Lauraner Knowles Estate, Preliminary Plan No. 120190080

Completed: 6/17/2019

Request to create 12 Lots for 12 townhouses, two outlots for future development, two HOA parcels, and one HOA Common Open Space parcel.

Figure 4 Applicant's Summit Avenue Cross-sections (Interim Condition, 75' ROW)

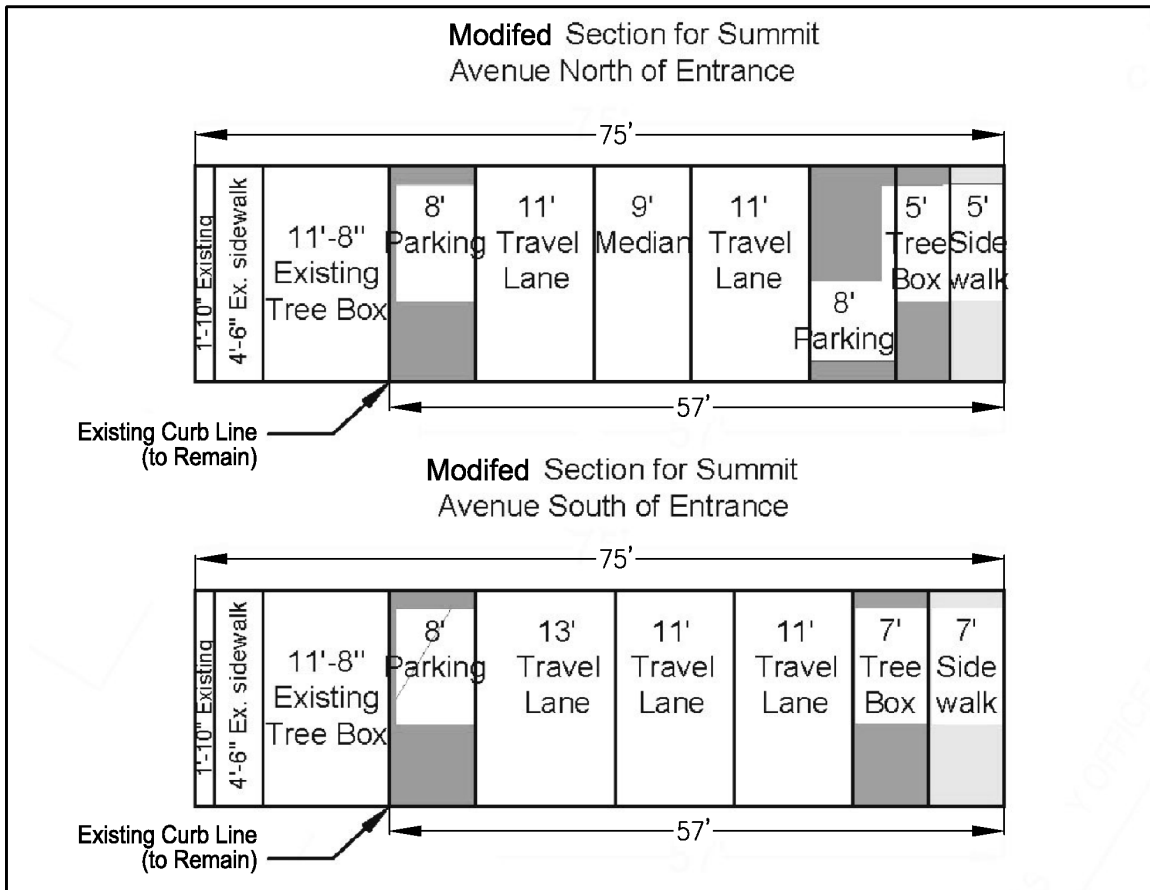
Issue — The Applicant is showing inadequate cross-sections within the existing ROW that do not include all required elements of the interim and final conditions of Summit Avenue (Figure 4). The plans do not include a maintenance buffer and include inadequate sidewalks. Staff supports MCDOT's recommended sections, which requires an additional five (5) feet of dedication. The additional dedication will allow for an interim (Figure 5) and final roadway condition, which will include a 10-foot-wide two-way separated bike lane with a three-foot buffer (Figure 6). The 10-foot-wide two-way separated bike lane cannot be constructed without the dedication of five (5) feet.

Figure 7 Northbound Lane Alignment Issues

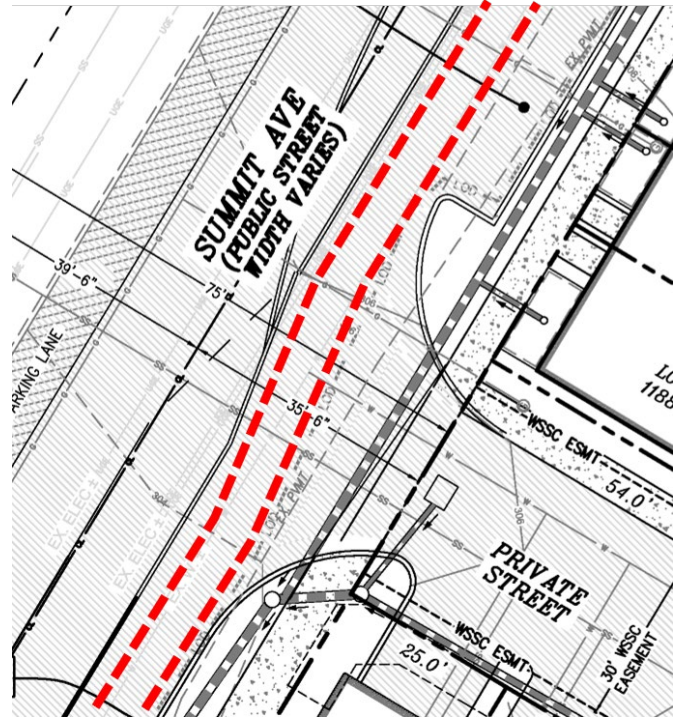
In addition to the cross-section missing maintenance strips and adequate sidewalks, the Applicant's cross-section includes a travel lane that is not properly aligned. The north-bound travel lane shifts at the entrance to the Property (Figure 7).

Figure 8 Summit Avenue Alley

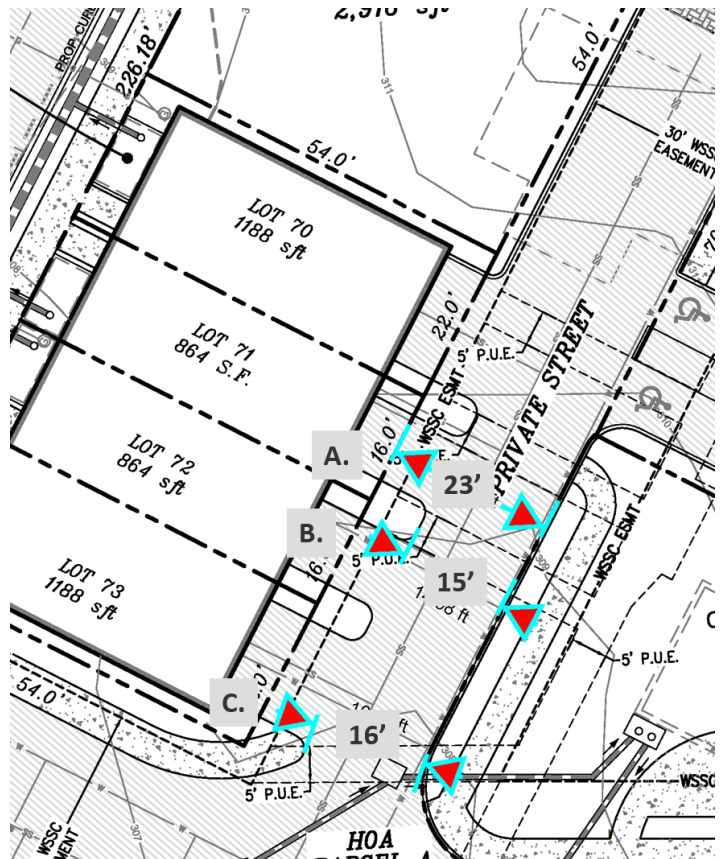
Issue — The internal vehicular system, labelled "Private Street", does not follow the cross-section provided, and is not designed to allow safe and efficient access and use. The Summit Avenue alley, behind lots 70-73 (Figure 8), has a ROW that is 23-feet-wide (measurement A), yet an entrance width of 16 feet (measurement C) and a traffic width of 15 feet (measurement B). The alley is an insufficient width to provide safe and efficient two-way travel.

Figure 9 Knowles Avenue Alley

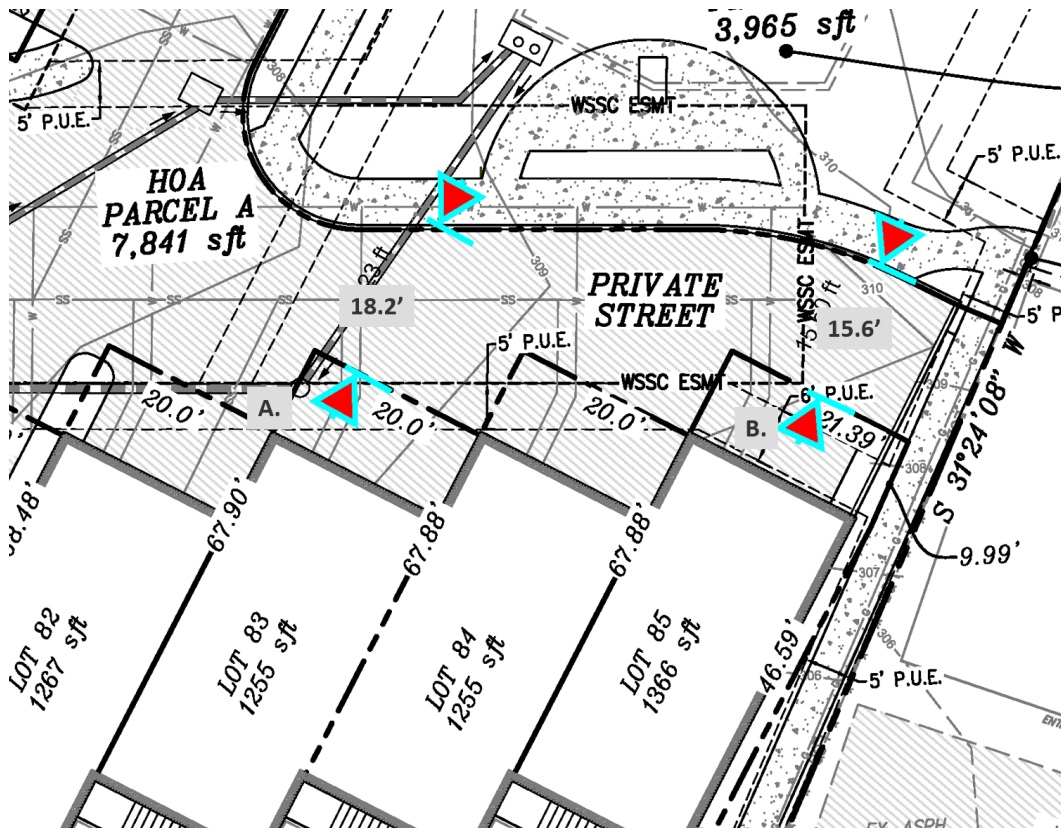
The Knowles Avenue alley, behind lots 82-85 (Figure 9), has a width that varies between 15.6 feet and 18.2 feet due to angled lots. Per Section 49-32(d)(8) of the Montgomery County Code, "The minimum right-of-way for a road may be specified in the applicable master plan or sector plan for the area where the road is located. If a minimum right-of-way for a particular road is not specified in a master plan or sector plan, the minimum right-of-way must be 20 feet for an Alley". While there is additional paving on private lots, those areas are considered driveways, are not a part of the private alley and they may be obstructed. The alley is an insufficient width to provide safe and efficient two-way travel. Furthermore, as a private road, the alley must be in its own separate parcel and must meet minimum corresponding public road standards. The typical ROW width for an alley of this design is 20 feet. While a narrower alley width can be approved by demonstrating that adequate turning movements and safe and efficient pedestrian access can be achieved with an accompanying cross-section, the Applicant has not been able to demonstrate adequate turning movements and safe and efficient vehicular and pedestrian access.

Figure 10 Knowles Avenue Alley Garage Access

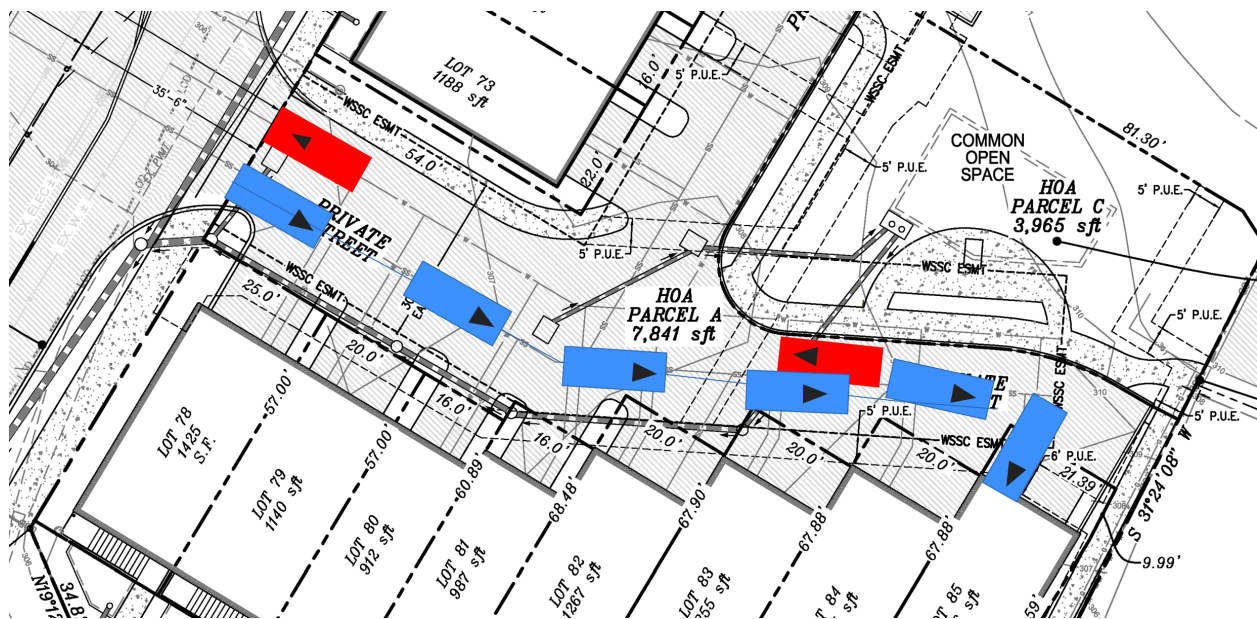
Issue — The Knowles Avenue Alley does not allow standard automobiles the ability to park head-in for units 83-85. A car is not physically able to turn into a garage within the space provided (Figure 10). The blue cars are inbound and attempting to access the garages; the red cars are outbound cars.

Figure 12 Fire Department Access Overlay

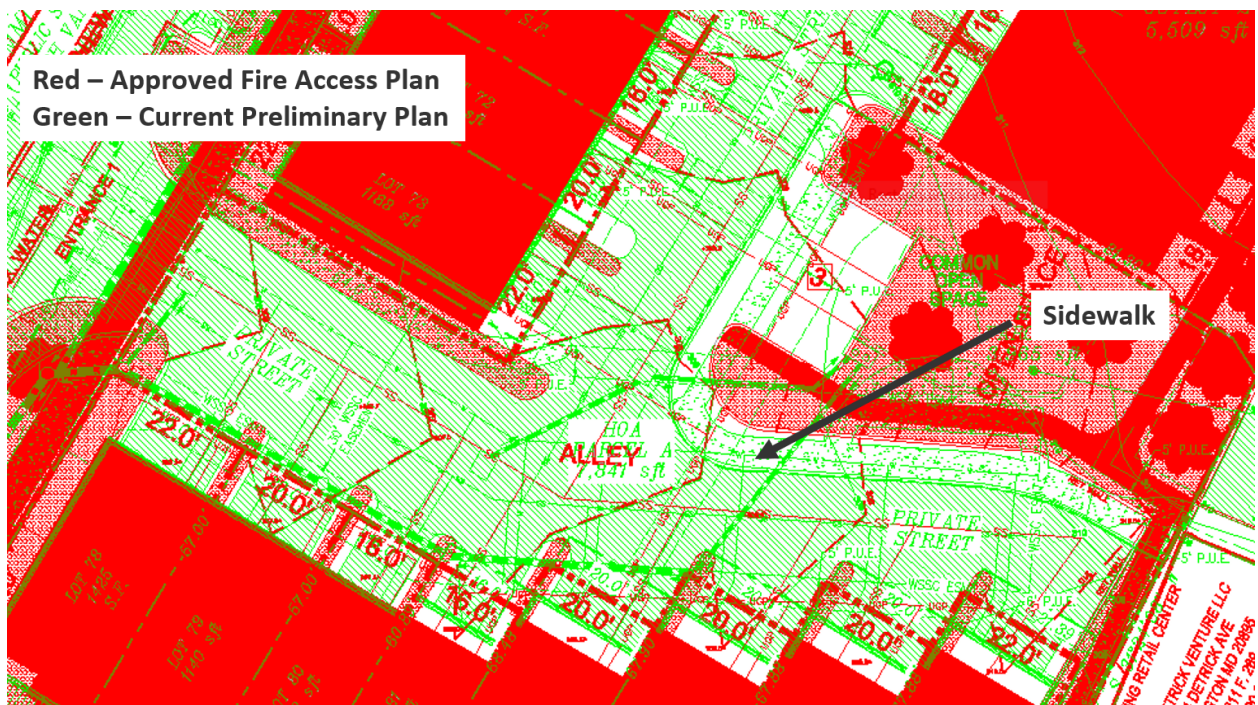
Issue — While the proposed project received a Fire Department Access Plan approval (Figure 11) from the Montgomery County Department of Permitting Services (MCDPS), Fire Department Access and Water Supply Section, on January 22, 2019, the internal alley system has subsequently changed with the final plan submittal on May 10, 2019. The current alley system conflicts (Figure 12) with the approved Fire Department Access Plan.

Figure 13 Cumulative Impacts of Changes

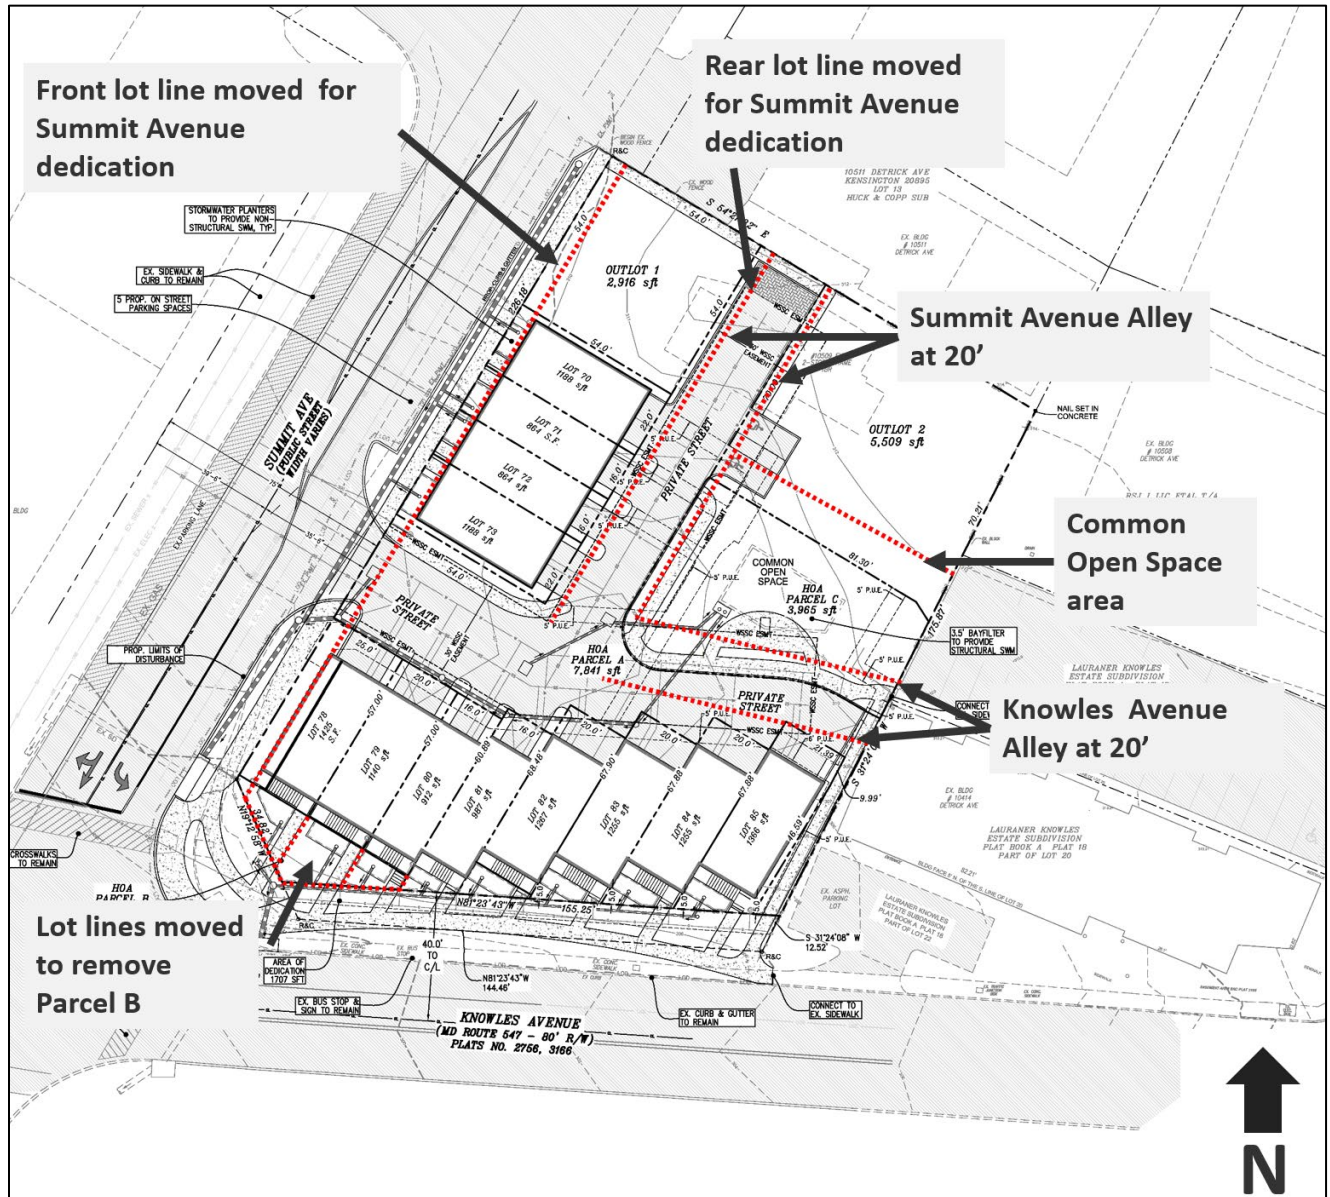
The cumulative impact of the required five (5) feet of dedication and alley redesign for a minimum width of twenty (20) feet will impact the size, configuration and location of the proposed lots, COS parcel and the outlots (Figure 13). There is no way to define the lot size, shape, width, orientation and configuration of lots that meet all requirements. For example, the orientation of the Knowles Avenue Alley will need to be adjusted to allow for vehicular entry into garages. Also, any new plan must be reviewed and approved for Fire Department Access.

Figure 15 Summit Avenue Alley

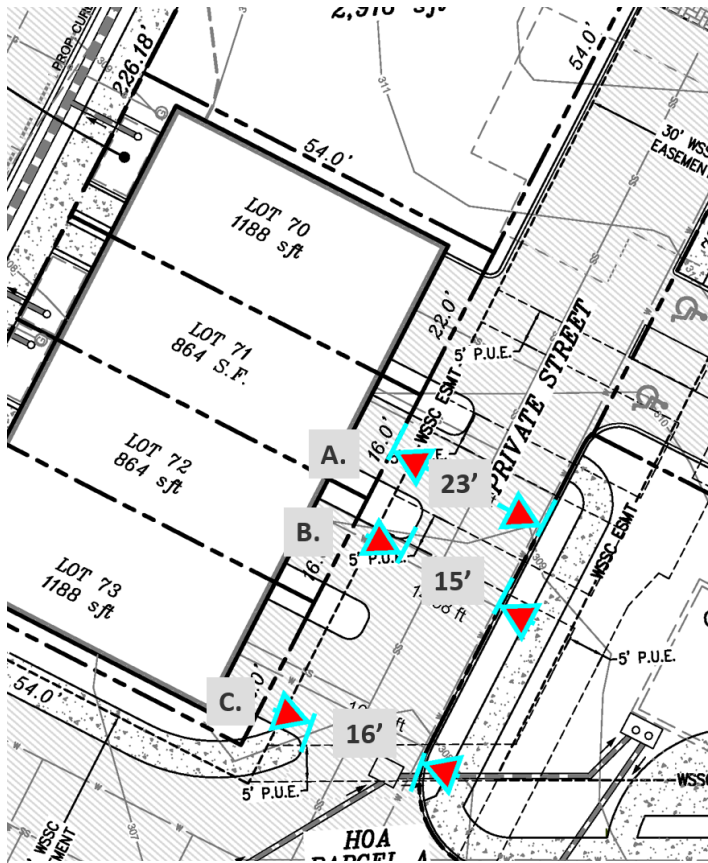
While the width between property lines is 23 feet (measurement A) along the Summit Avenue Alley, the unobstructed paving width is less than the minimum sixteen (16) feet required (measurement B).

Figure 16 Knowles Avenue Alley

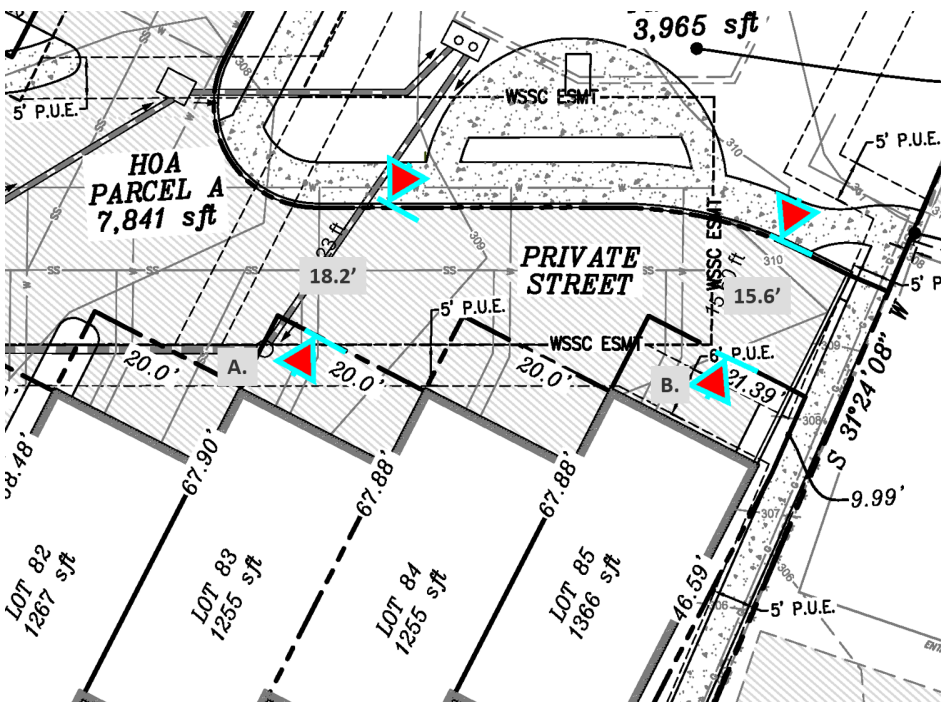
Knowles Avenue Alley has a paved area wider than the sixteen (16)-foot minimum required, this included paving on private driveways. Private driveways may be obstructed with parked vehicles. The distance between property lines is less than the twenty (20)-foot minimum specified in the standard (measurement A and B).
